Thomas Viaduct Middle School R&P Classroom Remodel (Non-Wage)
BID # 034.22.B4

Addendum 2
Date: March 22, 2022

**BID CLARIFICATION NO. 2
TO THE DRAWINGS
FOR**

**HOWARD COUNTY PUBLIC SCHOOL SYSTEM
THOMAS VIADUCT MIDDLE SCHOOL CLASSROOM RENOVATION
DLR Group Project No. 56-22107-00**

FIRST FLOOR PLAN - AREA 'B' - SYSTEMS
 SCALE: 1/8"=1'-0"

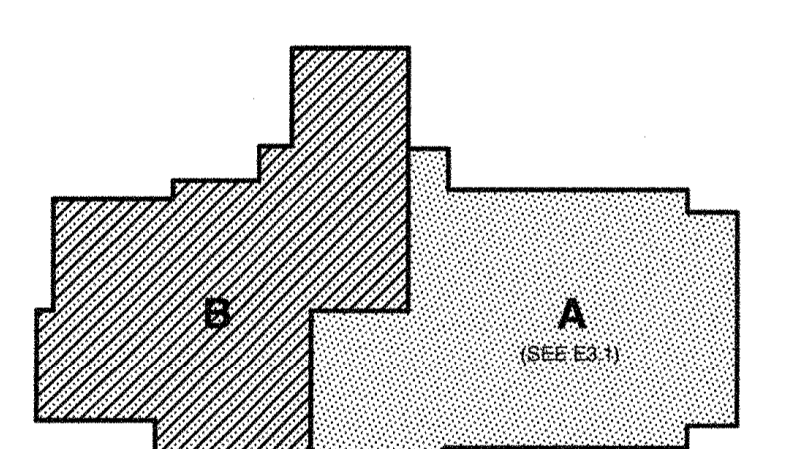
5	Drawing A1.1, Keynotes: 3.2 Note 14, Can you send a photo or give us a specification of the existing signage we must match?	Provide room signs manufactured and/or supplied by Andco Industries or by Signs and Wonders Inc. 410-442-8243. Room signs shall meet ADA requirements. Mount signs at height to meet ADA. See attached photo of the existing signage includes text and braille.
6	The site visit shows different receptacle colors. What color are we matching?	Black receptacles are typical outlets, grey receptacles are for computer power specifically. Only use grey receptacles where computer power is indicated.
7	Will there be summer school at this facility?	This school is not currently scheduled to host summer school.
8	Who is doing the final cleaning and waxing of the floors?	Contractor is responsible for final cleaning and waxing of new flooring.
9	Do you have the original fire alarm drawings showing the candelas for the existing devices?	See attached existing fire alarm drawings.

3A FLOOR PLAN-- NEW WORK ROOM B60, B61
 A1.1 SCALE: 1/4" = 1'-0"

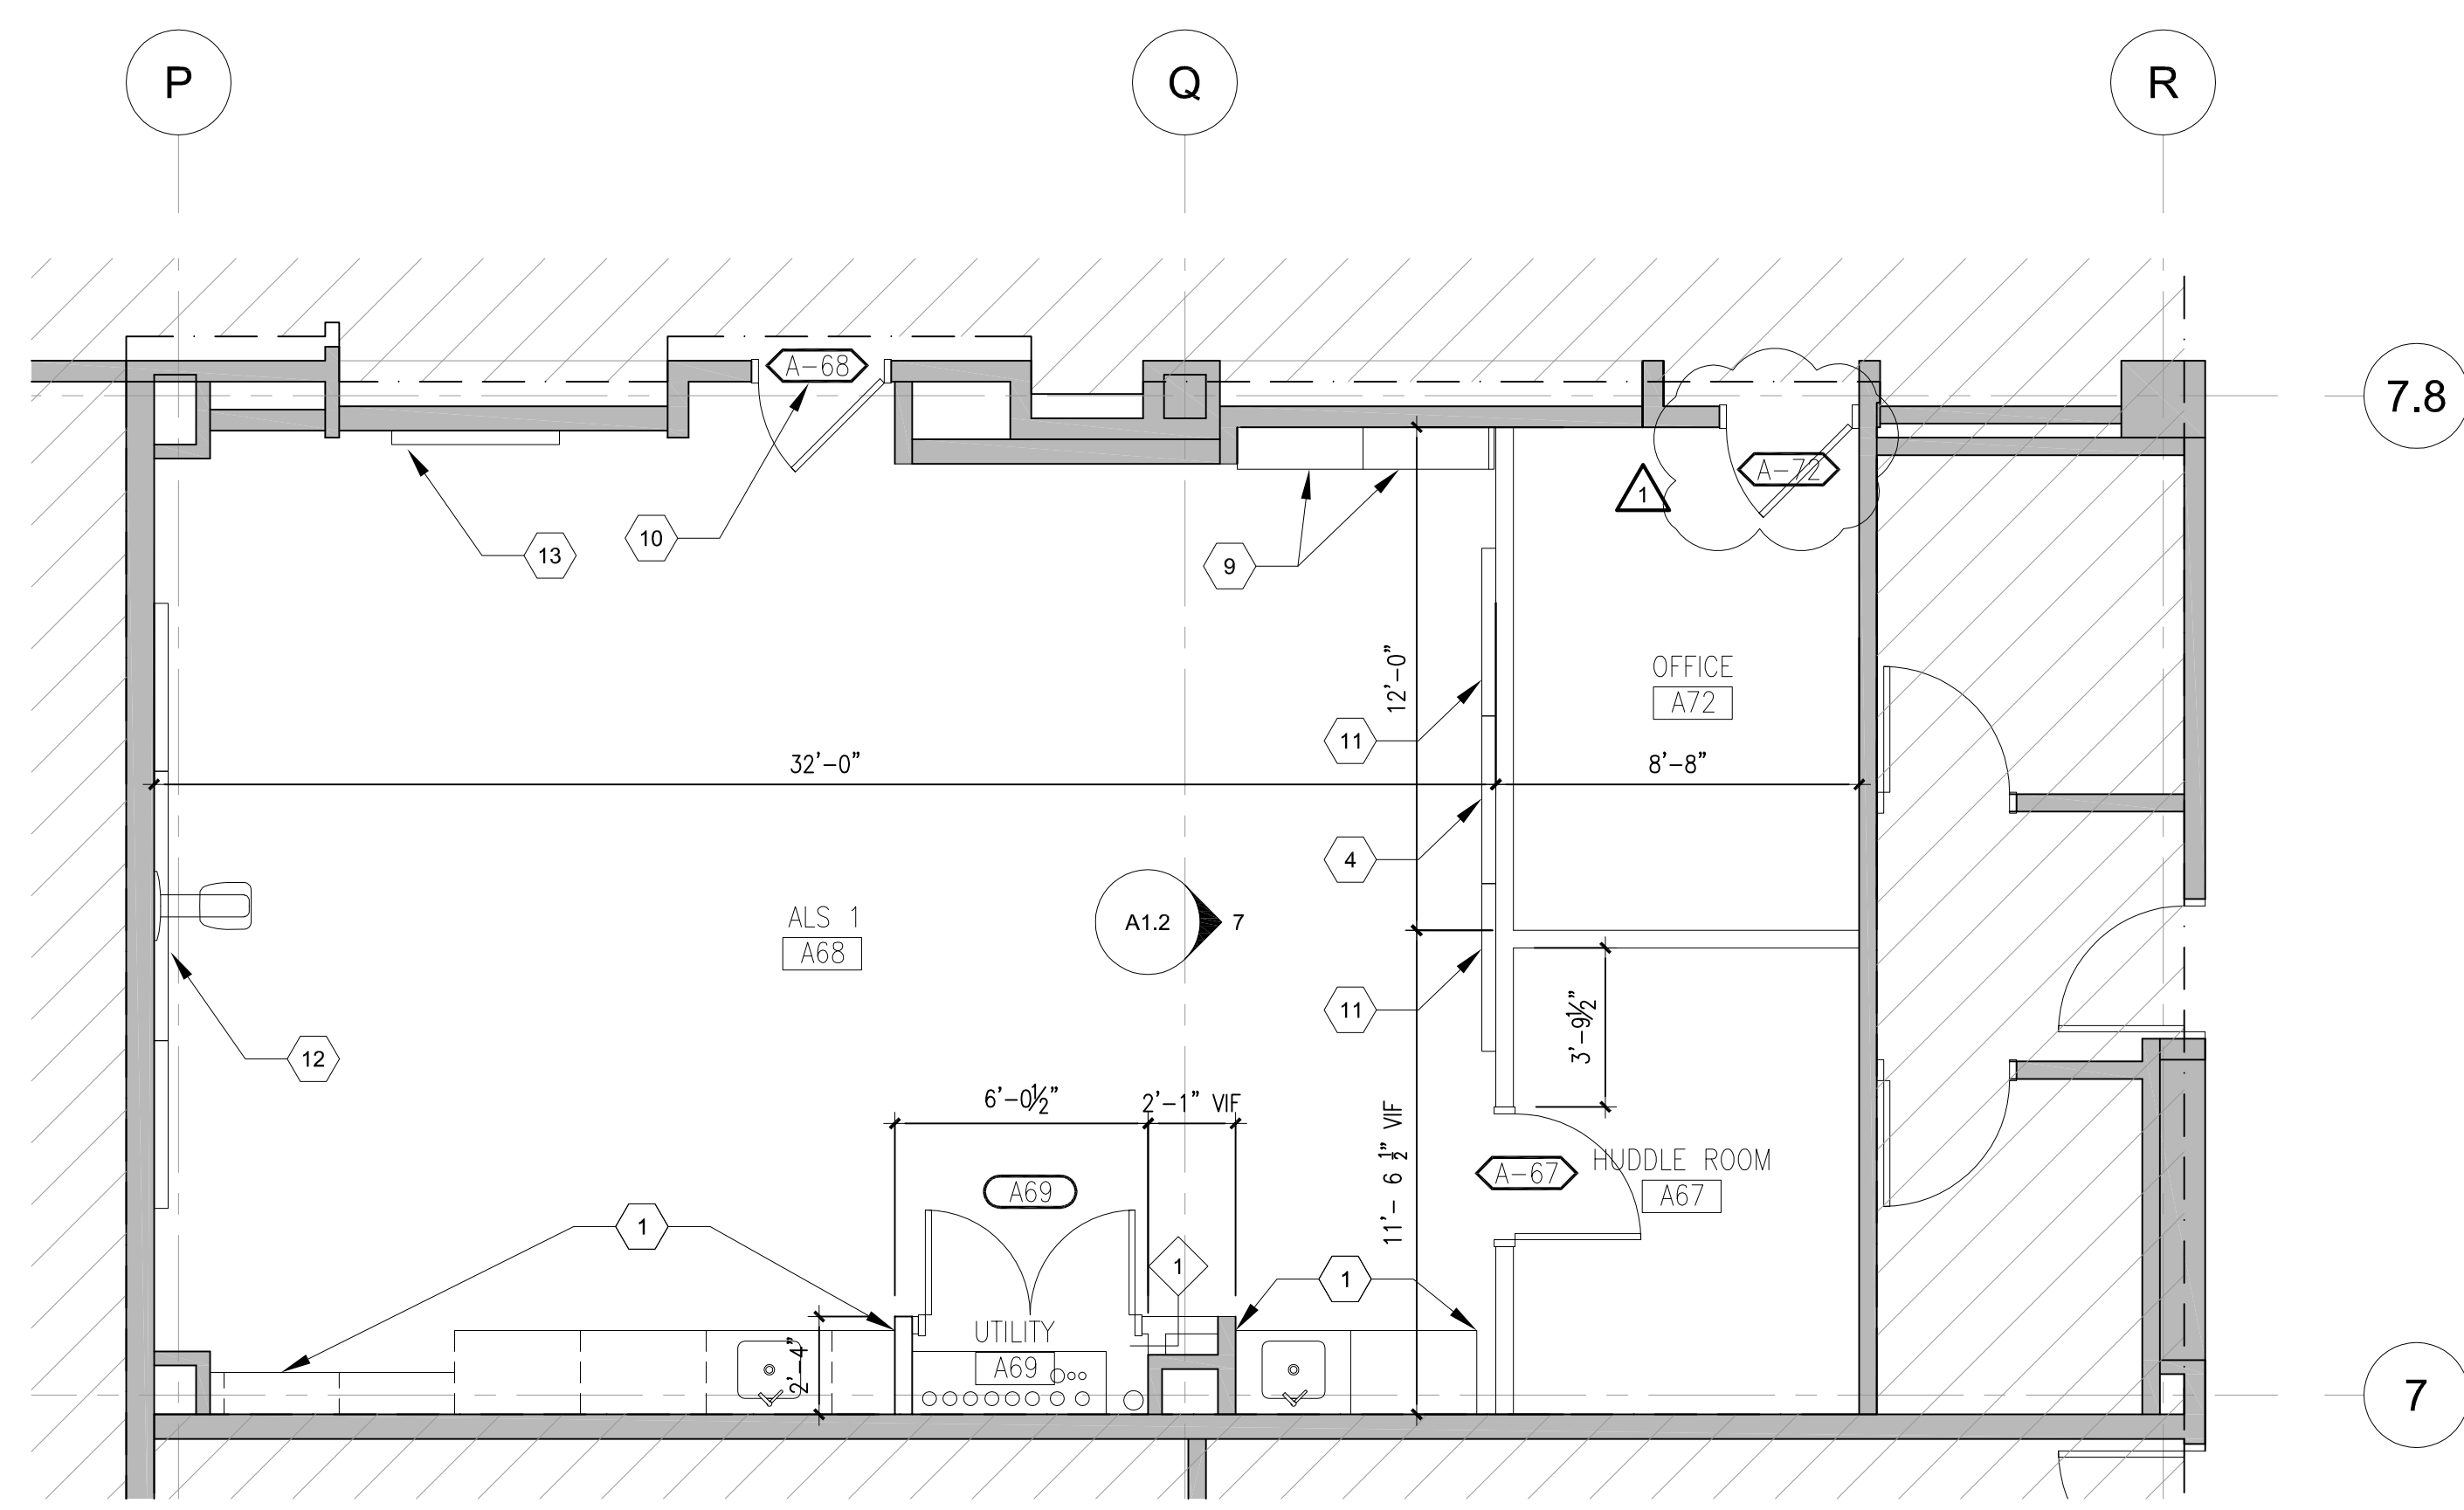
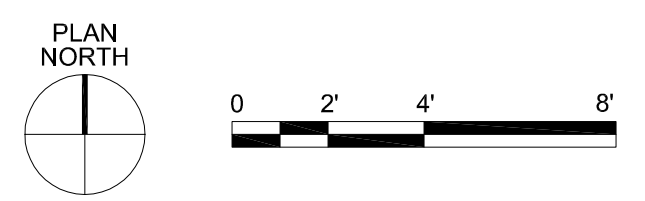
- At detail 3A/A1.1, change door swing at B-61 to RH into the classroom
- At detail 5C/A1.1, change door at A-72 to existing door and frame to remain.
- Change keynote #8 to “Reinstall clock removed from room A72 and B60.”
- At detail 3/A, add keynote 15 “Provide flag holder.”
